# Interoffice Memo

**Subject:** Magnuson Apartments – Additional Drawing Information

The Petitioner has submitted additional drawing information in advance of the November 18, 2021 Plan Commission consideration of the Residence at Brookside Glen / Magnuson Apartments – Special use for a PUD Substantial Deviation. The drawings were dated November 12, 2021 and received November 15, 2021. The additional drawing information includes updated sheets as well as newly submitted drawing sheets. The updated sheets consist of the building elevations (four sheets). The newly submitted drawing sheets show the currently proposed site plan, sheds/terraces, and cabanas near the pool.

A-001

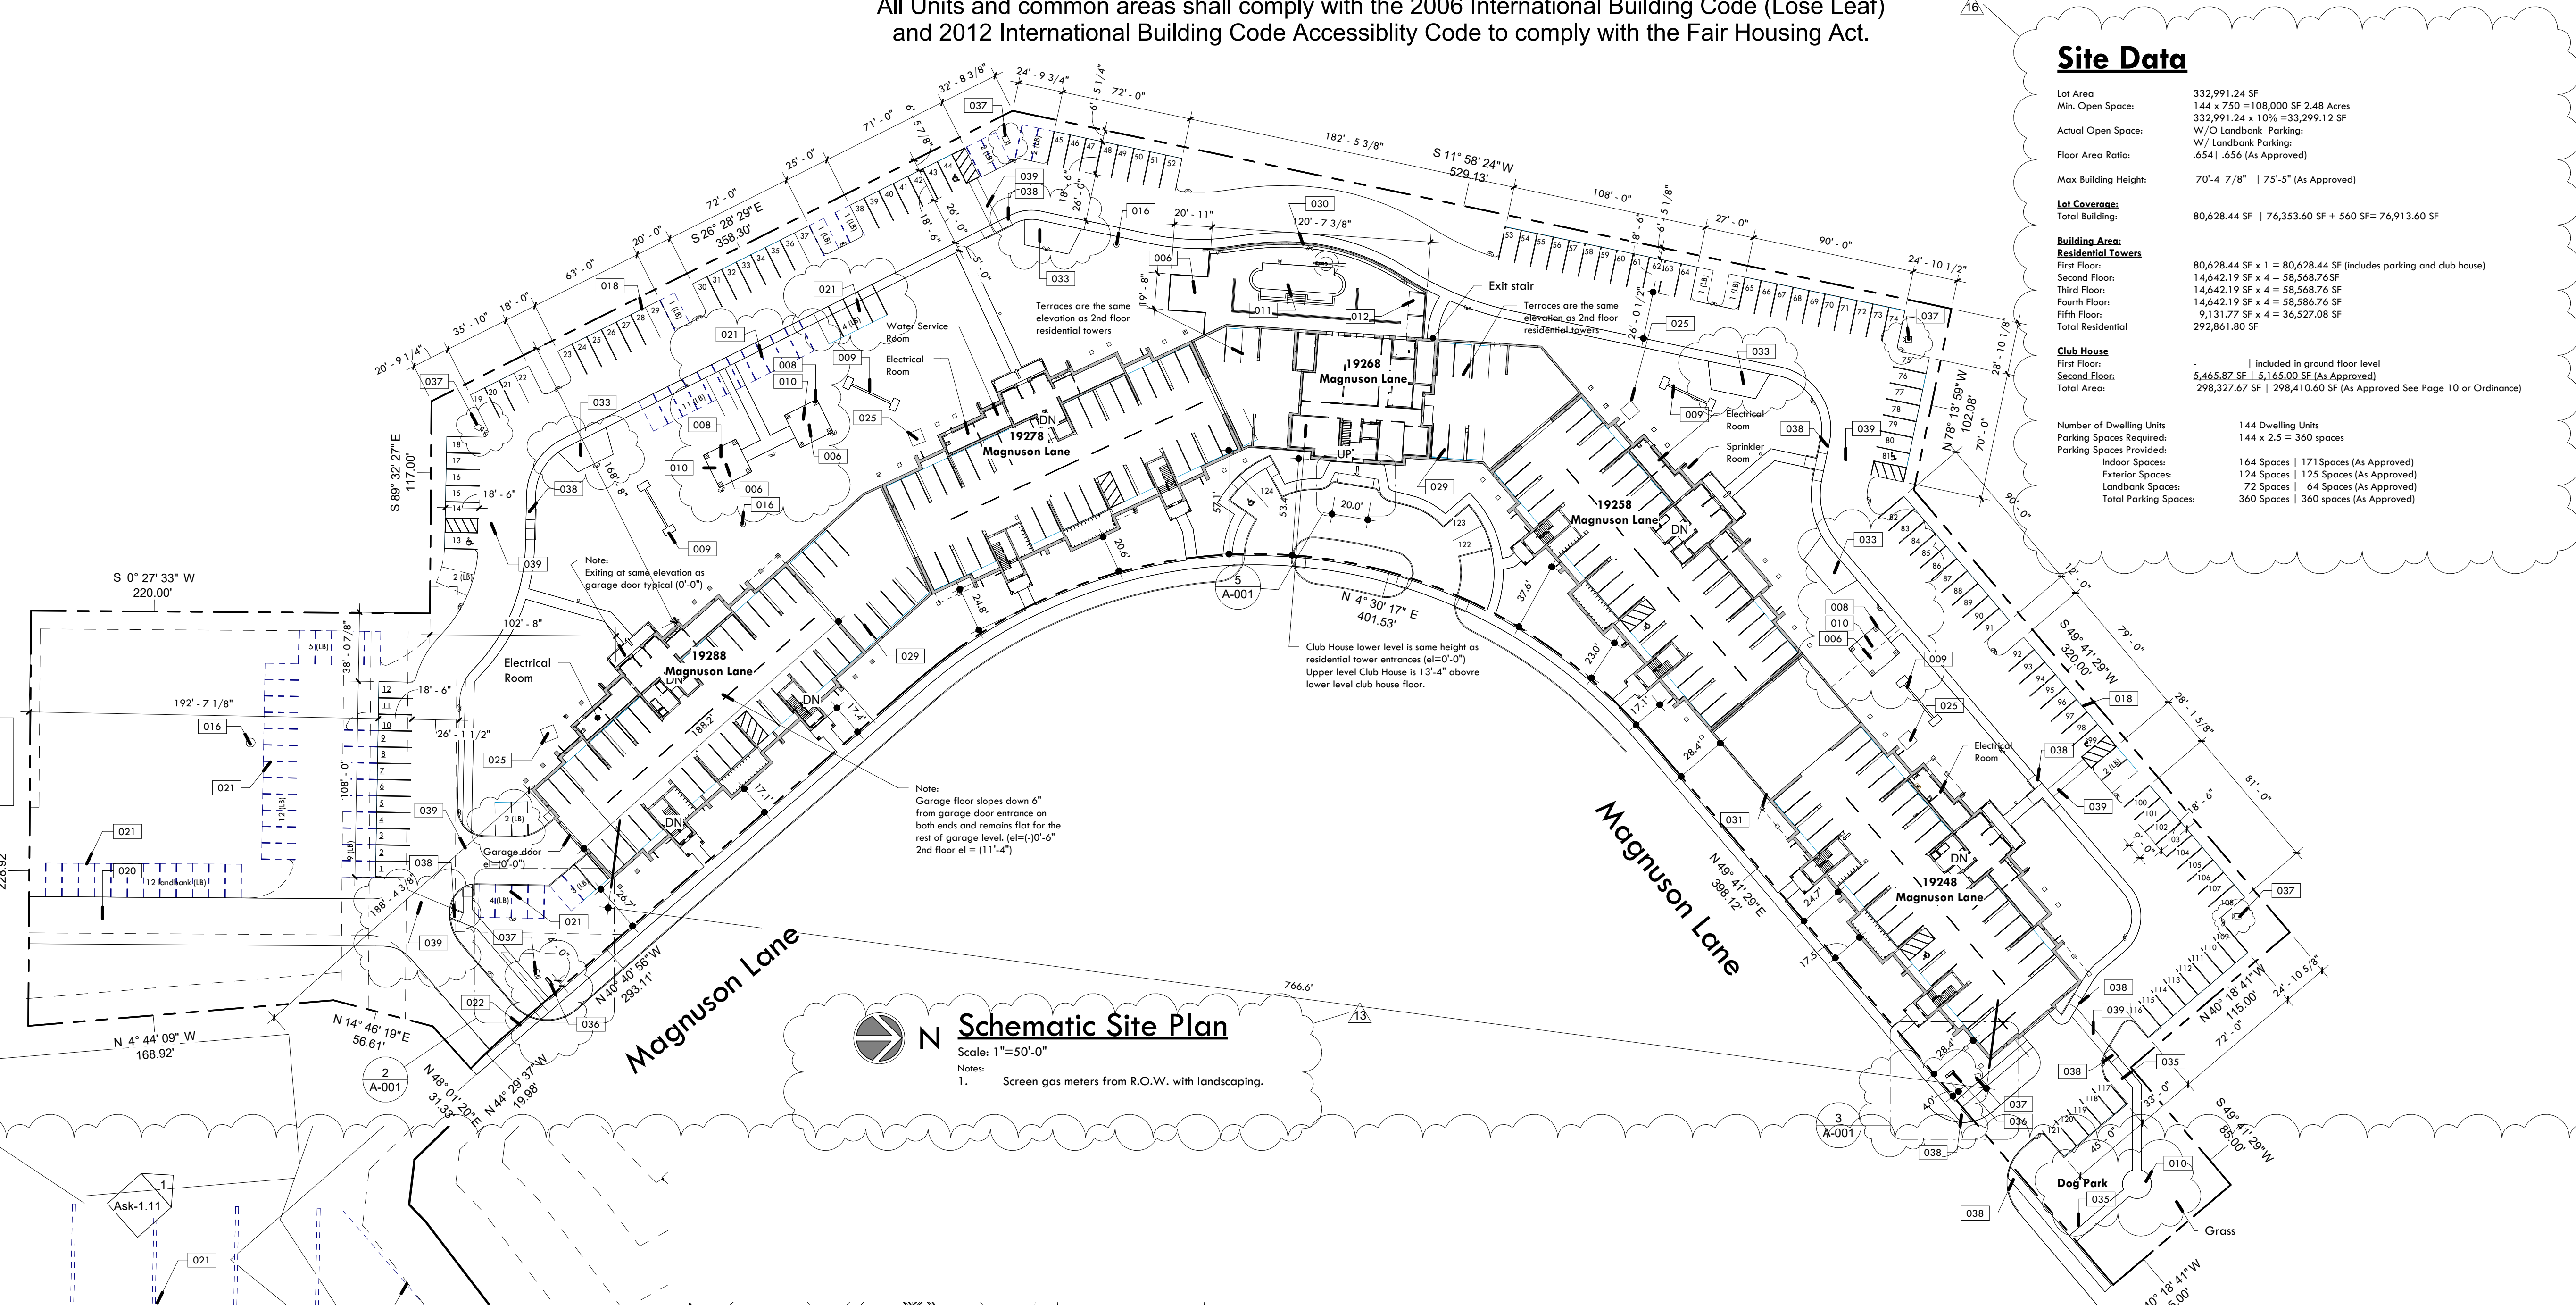
- (new) Schematic Site Plan A-001:
  - Parking: total remains same (counts increased landbanking, decreased interior/exterior)
    - EV Charging: count to be identified, listed as "Commercial"

- ADA/Handicap Spaces: meet state law requirements (note space at entry)
    - Increase in front yard parking from 2 (standard) to 4 (3 standard + 1 ADA)

- Passenger Loading Area: includes inset with slope and surrounding plantings, species/type not listed
    - Gas Meter Landscape Screening @ front by ROW: Species/type not listed

- ComEd Transformer Pads @ rear: Identify if landscape screening
    - Security Cameras added
    - Signage (size and 4'-0" setbacks remain): updated locations & material includes 4-way wash on cap and thin stone face to match building

- Trash Enclosures from 2 to removal; location(s) to be identified
- Pergolas: from 7 (terraces) reduced to 3 (ground)
- Seating: from approx. 20 tables (all terraces) reduced to small area on flanking terraces with similar area on central terrace

- Firepits: from 7 reduced to 4
- Workout Areas: from 4 reduced to 3
- (new) Connector & Exhaust Fan Enclosure (Sheds & Terraces) A-001.1
  - Flanking terraces have larger green roofs and narrow pedestrian/seating area whereas central terraces have smaller green roofs with larger pedestrian area

General Area of Cabanas  
Developer is reviewing the three cabana options above. Option 2 "12'x12' Commercial Del Mar Presidential Cabana with Marine Grade Fabric" is strong favorite

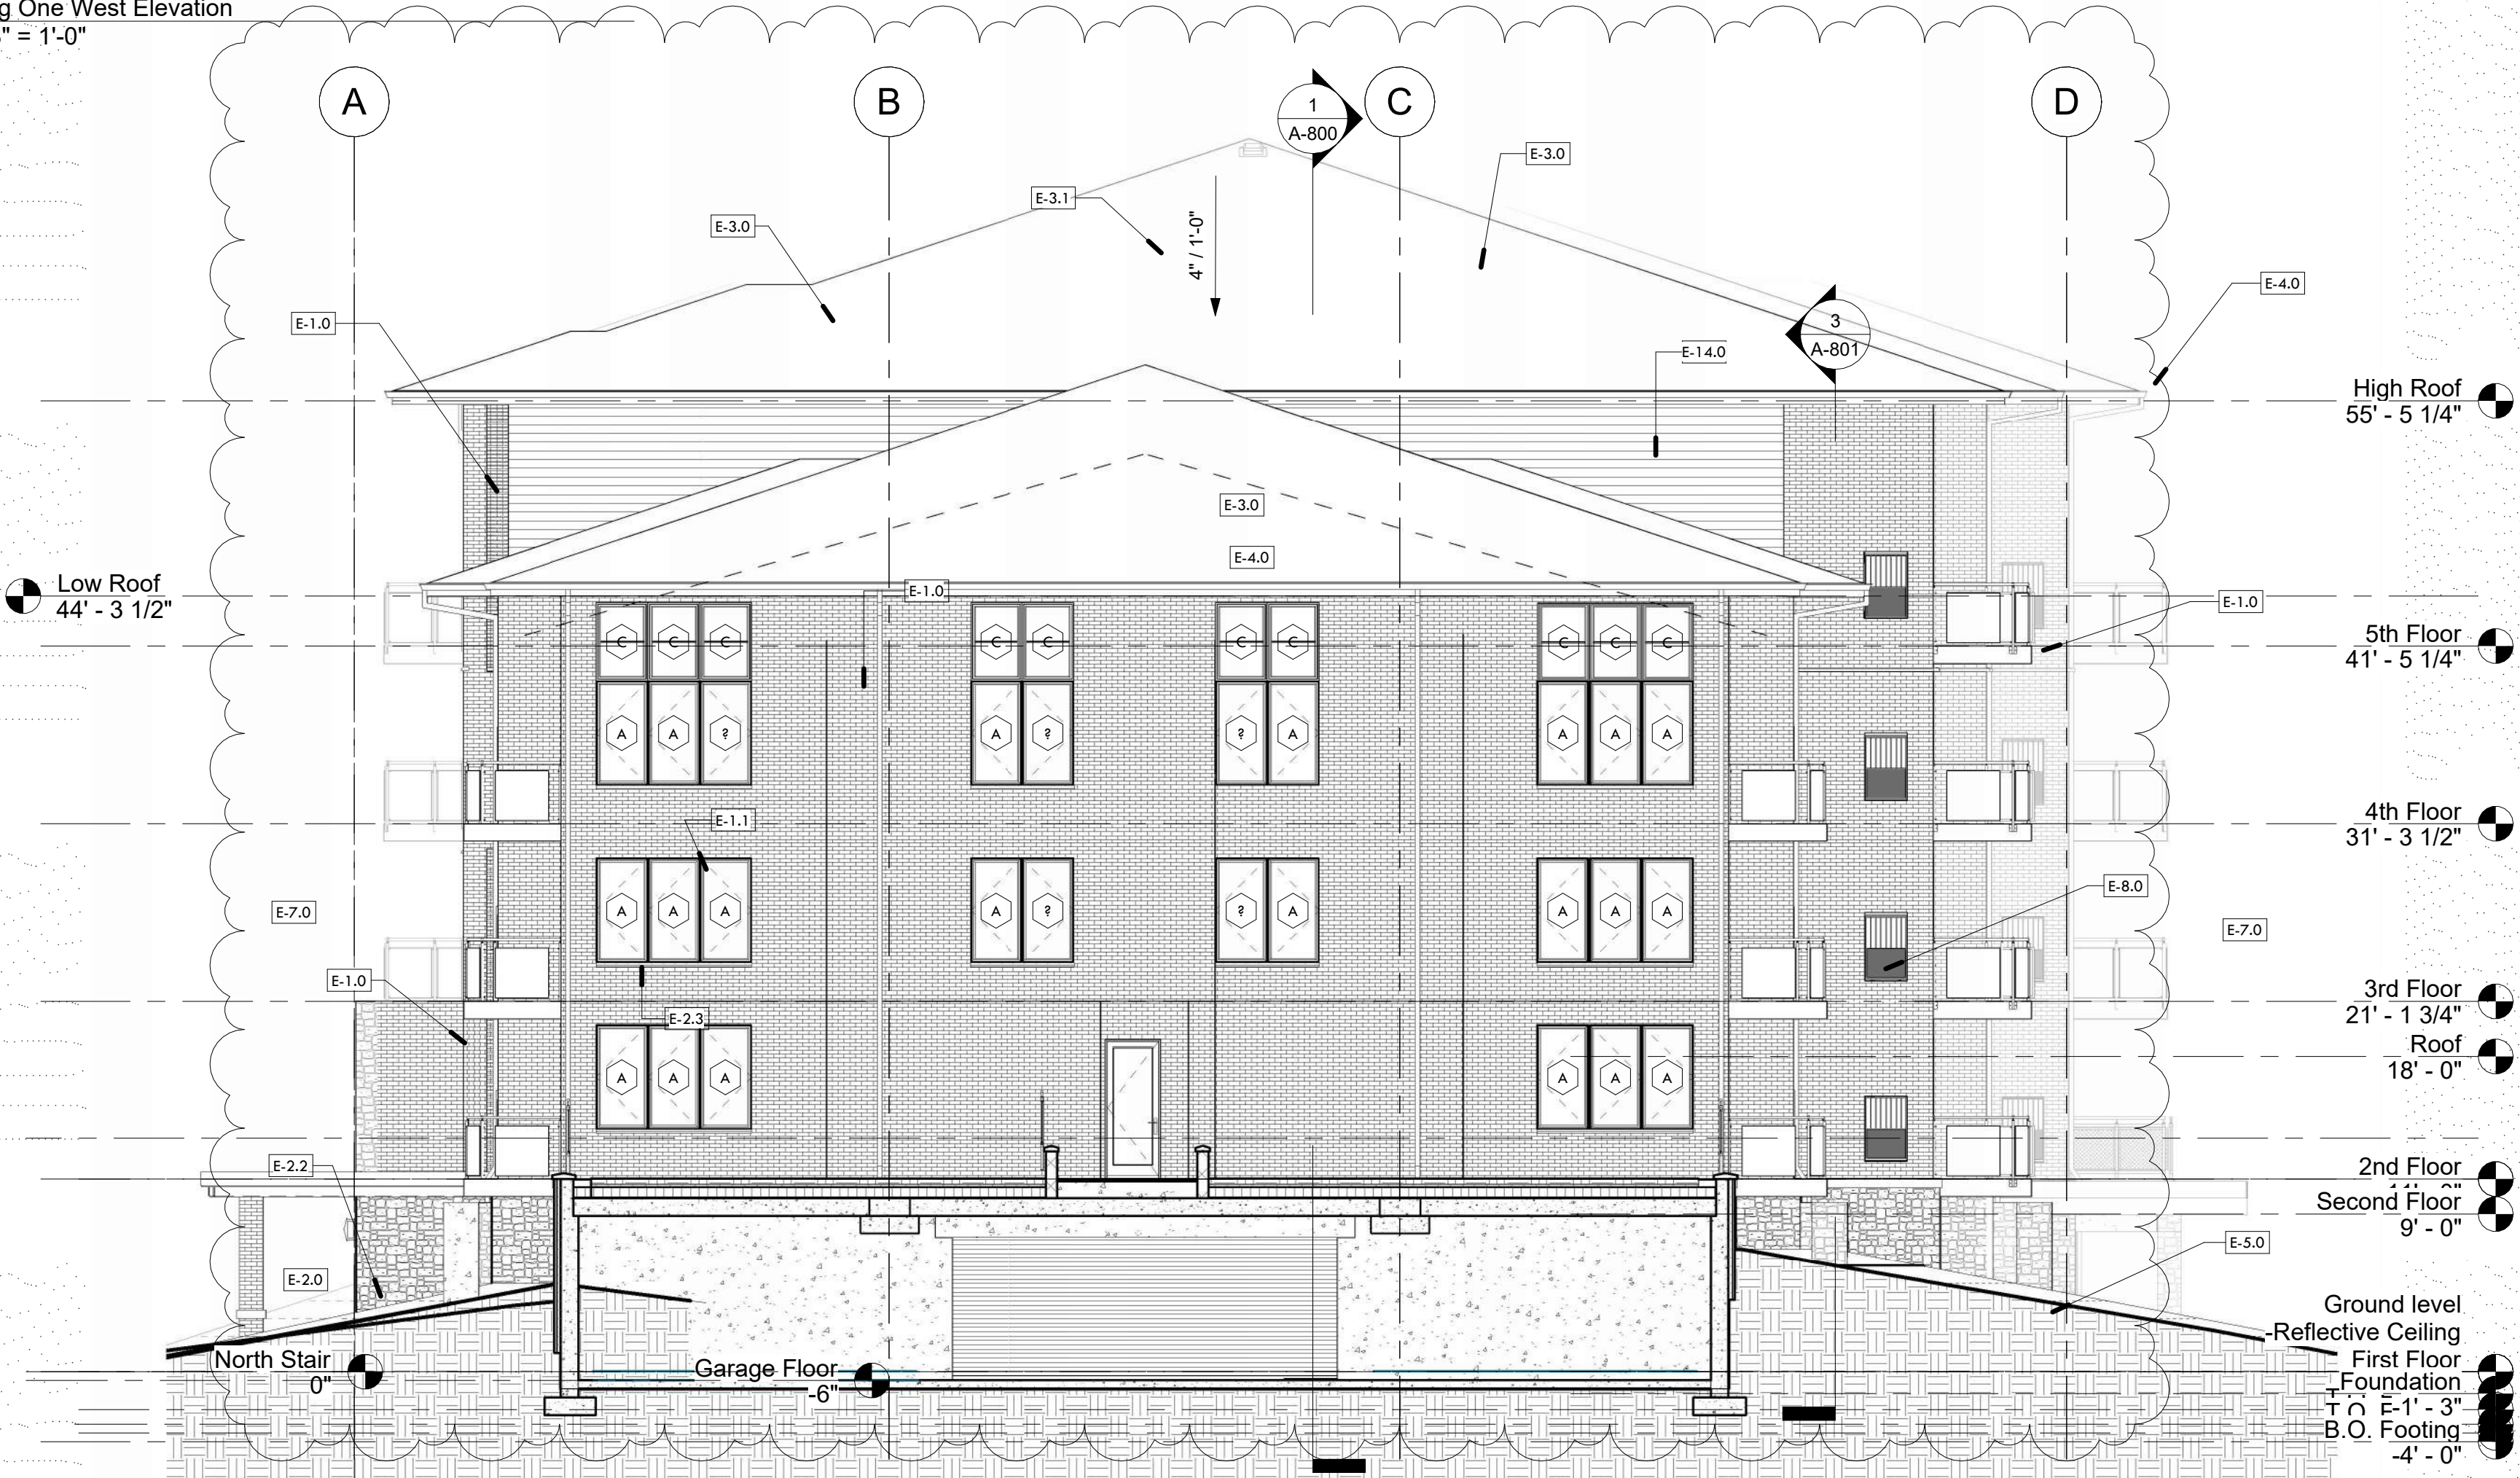
- Color of sheds' metal vents to be identified
- (new) Cabana A-001.2
  - Developer is reviewing 3 options (preference for the 12"x12" marine grade fabric)

A-101

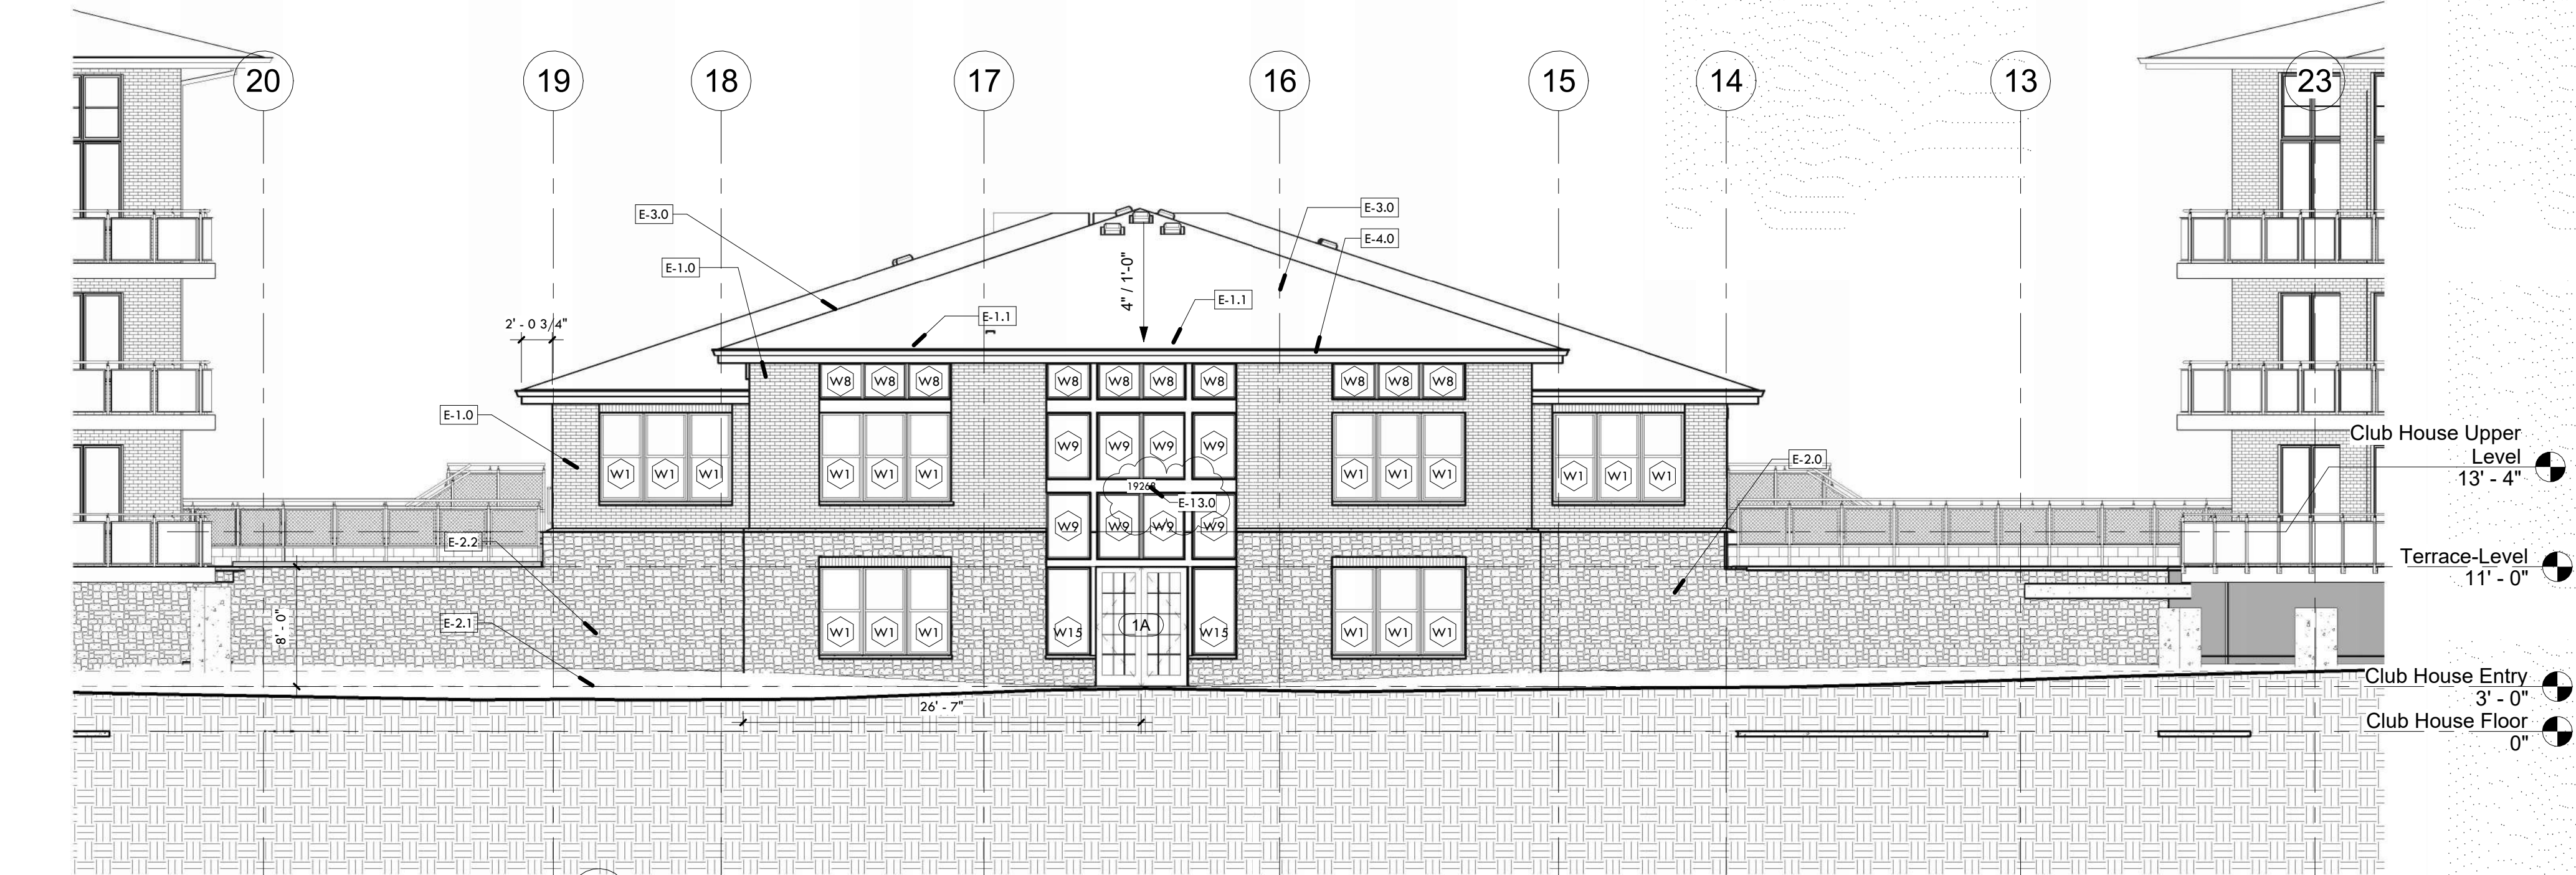
- (updated) Building One & Club House Elevations A-100, A-101, A-102, A-103
  - Residential east (front street-facing) entry canopy piers now are brick (not stone) with a 6" high stone accent strip

- A-100 & A-101 legends now list HardieBoard lap siding (was previously missing)
  - Drew in missing stone hatching on club house sides
  - Additionally, Staff notes the club house eaves are 2'-0 ¾", not the 4'-0" eaves as on the residential buildings
